Model: Model PE-MF2	Date: 16-Feb-09	No.: RM018001f
---------------------	-----------------	----------------

Subject: Firmware History - Engine		Prepared by: H.K.	
From: 2nd Overseas Tech Support Sec., 2nd PQM Dept.			
Classification:	<input type="checkbox"/> Troubleshooting	<input type="checkbox"/> Part information	<input type="checkbox"/> Action required
	<input type="checkbox"/> Mechanical	<input type="checkbox"/> Electrical	<input type="checkbox"/> Service manual revision
	<input type="checkbox"/> Paper path	<input type="checkbox"/> Transmit/receive	<input type="checkbox"/> Retrofit information
	<input type="checkbox"/> Product Safety	<input checked="" type="checkbox"/> Other (Firmware)	<input checked="" type="checkbox"/> Tier 2

Model: Model PE-MF2		Date: 16-Apr-09	No.: RM018004
Subject: Scanner Lock Error		Prepared by: H.K.	
From: 1st Tech. Support Sec. Service Support Dept.			
Classification:	<input checked="" type="checkbox"/> Troubleshooting	<input checked="" type="checkbox"/> Part information	<input type="checkbox"/> Action required
	<input type="checkbox"/> Mechanical	<input type="checkbox"/> Electrical	<input checked="" type="checkbox"/> Service manual revision
	<input

DECAL – ID CARD COPY

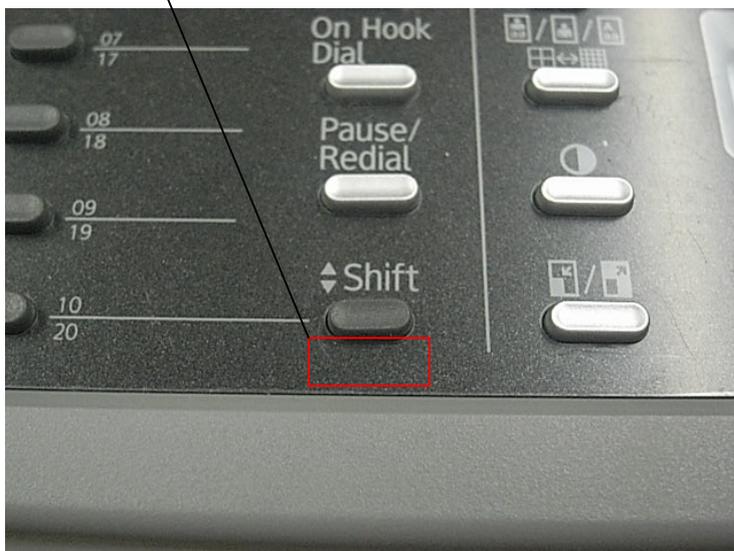
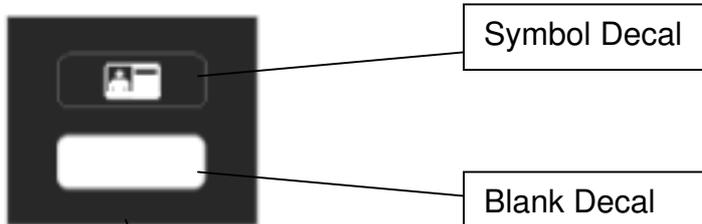
Change: The ID card copy decal was newly added as an accessory.

Interlock switch arm

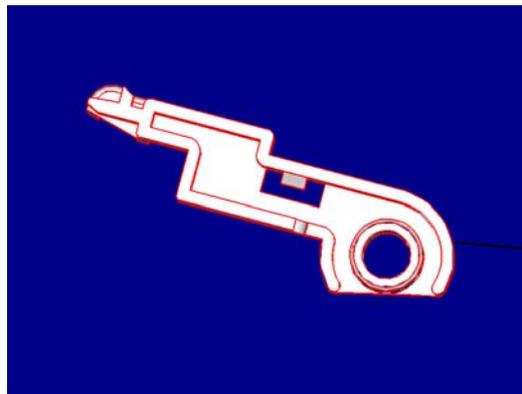
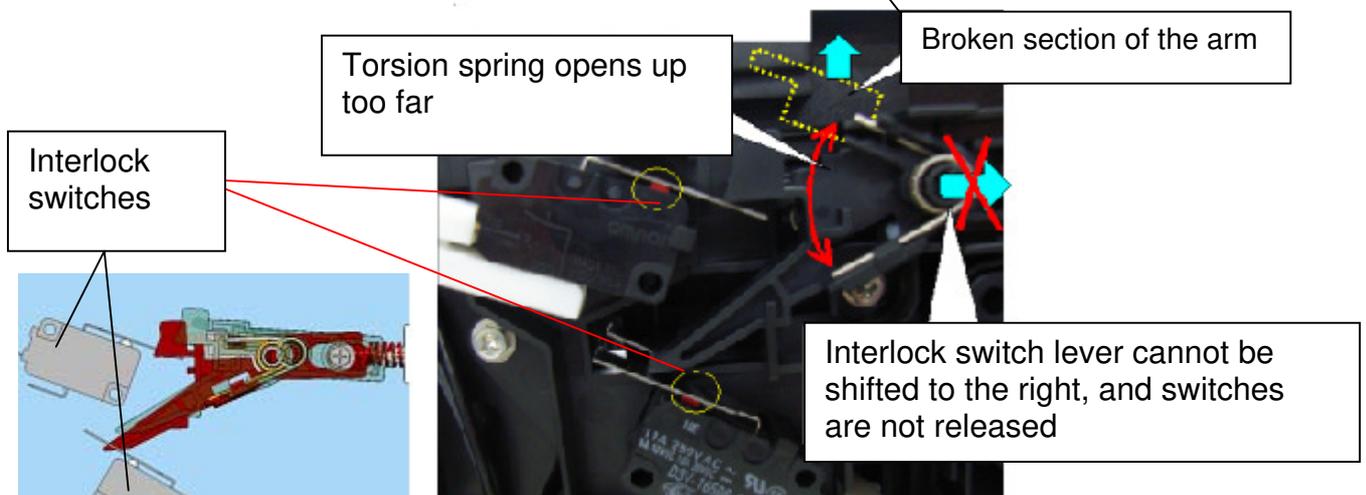
The interlock switch arm (G1665747) breaks, which causes the torsion spring to open up too far. As a result, the interlock switch lever cannot be shifted and the interlock switches are not released, preventing the machine from detecting the cover open condition.

Replace the interlock switch arm with a new one (G1665754).

The new interlock switch arm (G1665754) is stronger than the previous one (G1665747).

Pinched Scanner Interface Harness

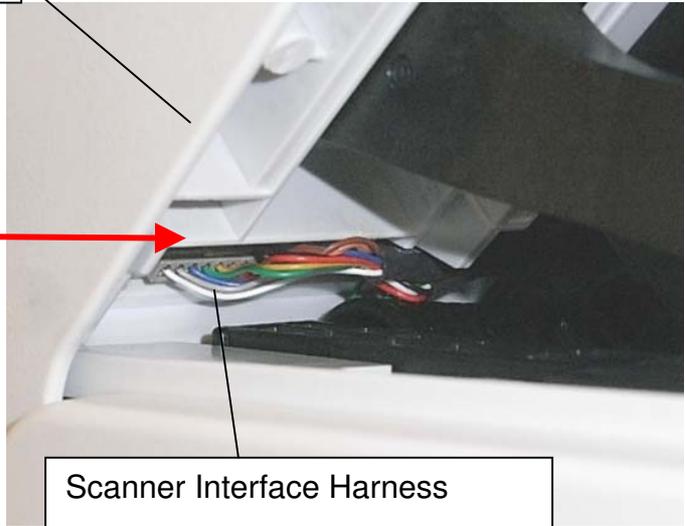
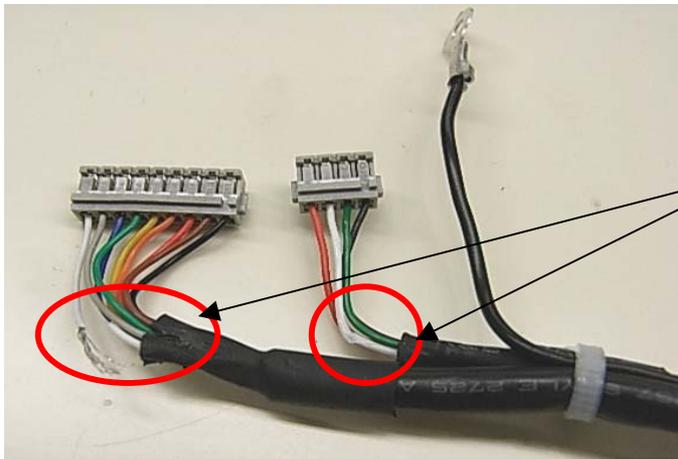
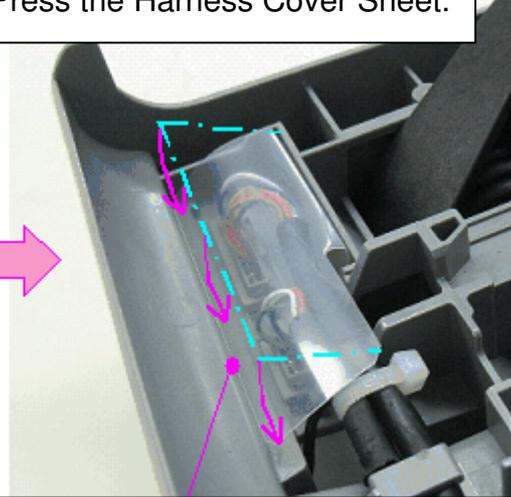
A protective sheet (Harness Cover Sheet, P/N: M0185757) was added to machines in production.

Attach the Harness Cover Sheet

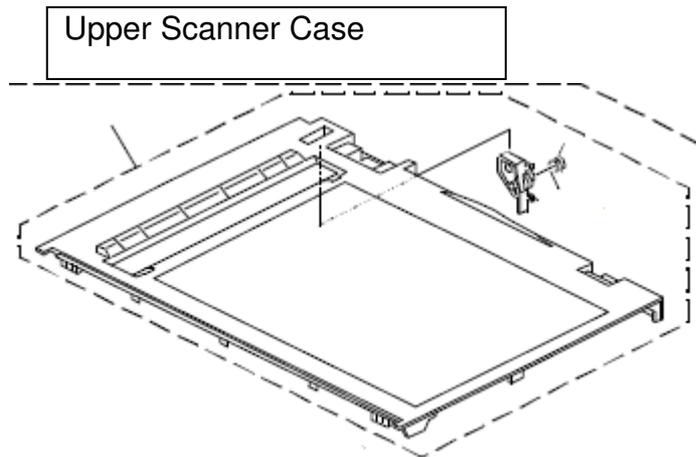
Change/Reason: P/N G1831820, which does not include the white plate, was registered as a service part by mistake.

Note: It is not possible to replace the white plate in the field individually. P/N G1831757 contains this white plate.

Four ribs added to Guide:Feed:Driven

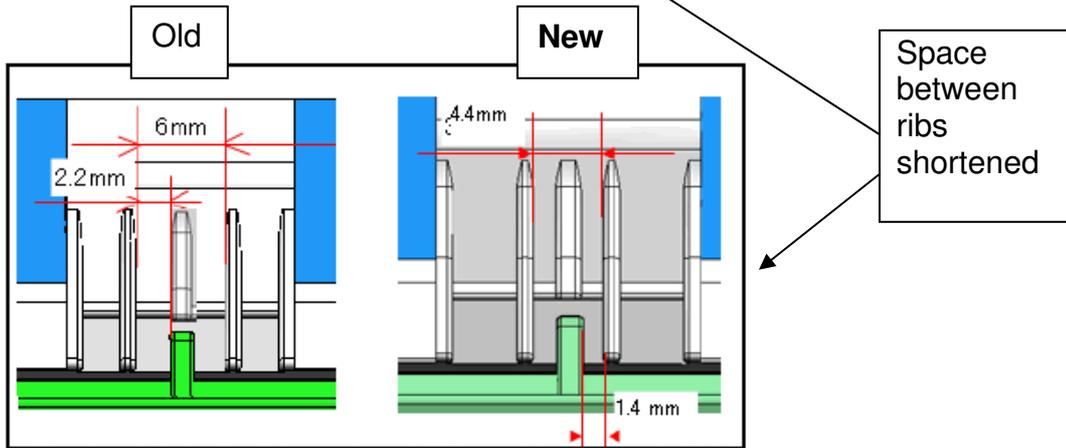
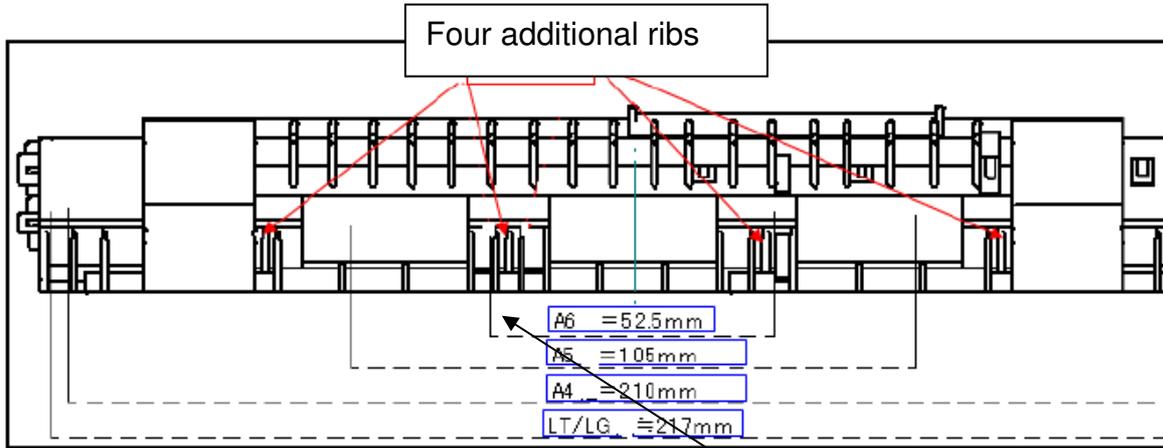
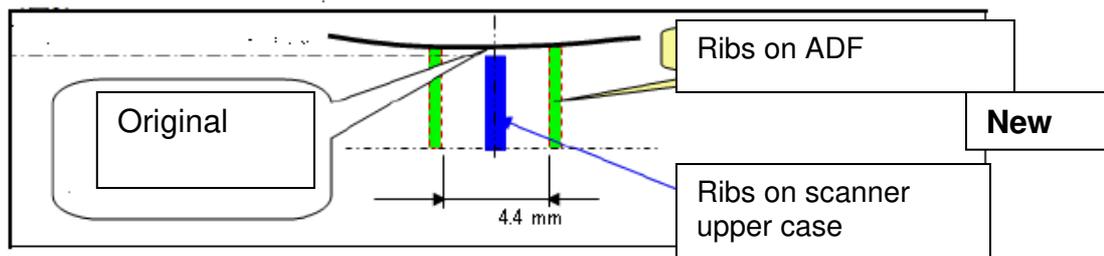
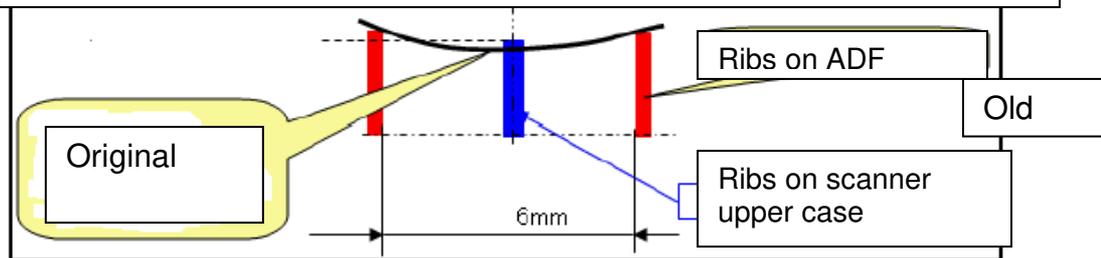
- Four ribs were added to the "Guide:Feed:Driven".
- The height of the ribs on the ADF was increased by 1 mm.
- The space between the ribs was shortened.

Glue melted
Upper Scanner Case

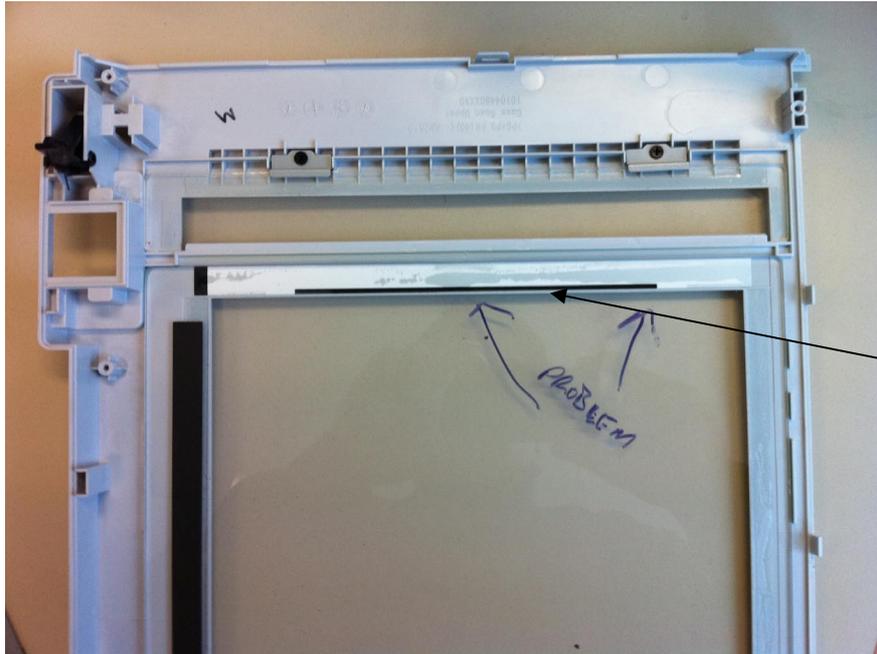
1. The following were added to the production process from September 25, 2011.
 - No cleaning solvents (including pure alcohol) are used to clean the shading sheet, exposure glass, and upper scanner case.
 - A visual check is performed to make sure that glue cannot be seen between the exposure glass and white plate, after the glue has dried.
2. A new type of glue is used to attach the white plate. This glue will not melt in high-temperature, high-humidity conditions, nor by cleaning solvents.

1. If the symptom occurs, replace the upper scanner case or scanner unit.
2. To prevent occurrences, do the following:

G1662580 Paper Feed Roller Shaft

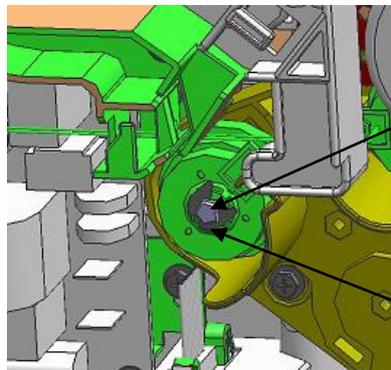
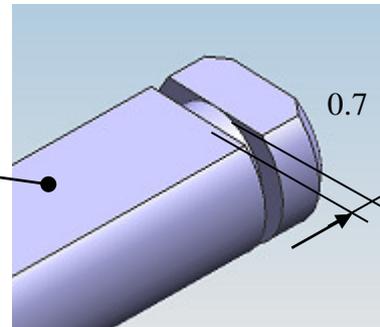
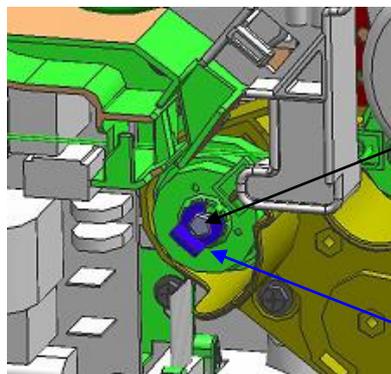
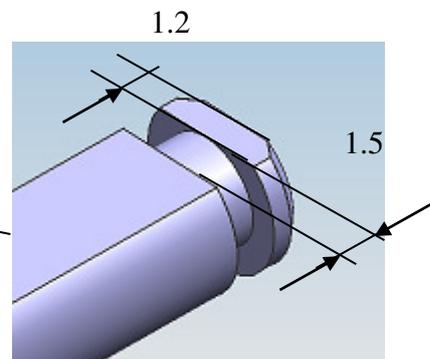
08050089 → H5213355
